Access Compliance Report

Public Rights-of-Way

(Pedestrian Signals)

Intersection ID: N/A	Main Street:	Cross Street: N/A	Location: N/A
ADA ID: 1999517969A2	Signal Type: One Push Button-Non APS	Overall Compliance: No	Severity Score: BTN 1: N/A BTN 2: N/A No BTN: N/A
Codes/Mitigation Info/Possible Solution		Field Measurements/Component Compliance

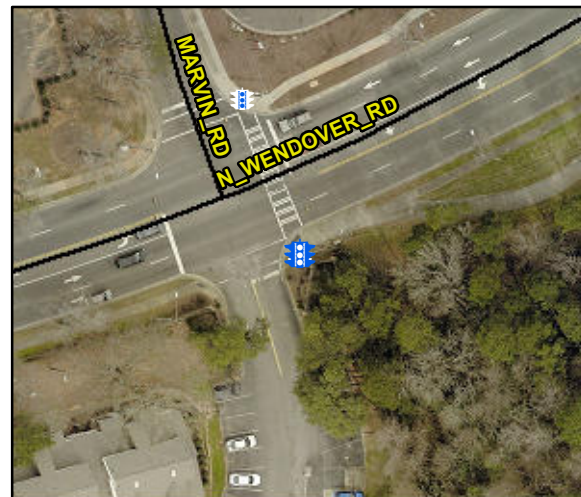
PROW/ADA: TMUTCD 4e.08, R404.2

Yes B 1 Clear Xing Direction?	ClearlyMarked	N/A B 2 Clear Xing Direction?	N/A
B 1 Crossing Direction	To NW	B 2 Crossing Direction	N/A
Yes B 1 DistanceTo XWalk (in)	0.0	N/A B 2 DistanceTo XWalk (in)	N/A
No B 1 DistanceTo Curb (in)	114.0	N/A B 2 DistanceTo Curb (in)	N/A
Yes B 1 Diameter (in)	2.0	N/A B 2 Diameter (in)	N/A

Possible Solutions: Replace Signal Push Button With APS Button on New Post. Remove & Relocate Sign.
